Berol Quarter: Wind Microclimate Peer Review

Architectural Aerodynamics Limited (ArcAero) has been appointed to carry out an independent review of the November 2022 pedestrian level wind microclimate assessment submitted in support of the planning application for the proposed Berol Quarter development (Planning Reference No. HGY/2023/0261), in the London Borough of Haringey. The wind microclimate assessment was undertaken by WSP and is documented in WSP report dated 8 November 2022 (Project No 70094918 rev 003). This review is based on the contents of this document.

Figure 4-6 – Winter Comfort Criteria for the Proposed scenario

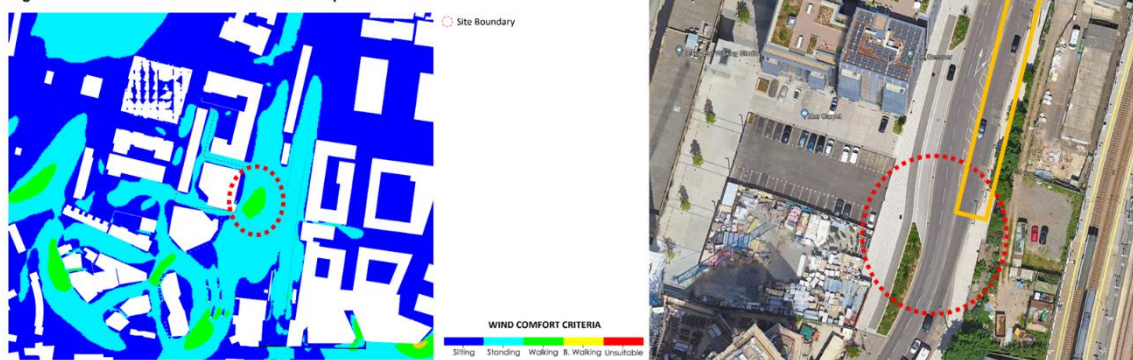
- 2.6. In terms of pedestrian comfort, it is noted that wind conditions at pedestrian level are generally suitable for intended uses, but with a number of off-site areas where the comfort criteria were not met, similar to the Baseline, thus not requiring mitigation. This result, as presented, is considered plausible, with the exception of a single area. There is an area along Watermead Way (nearby receptor 23) that appears to be coincident with a nearby bus stop (highlighted in an orange box in the image below) where leisure strolling conditions appear. Please clarify if this region of leisure strolling conditions overlap with this bus stop area, and if such, mitigation measures will need to be recommended and validated for this area.
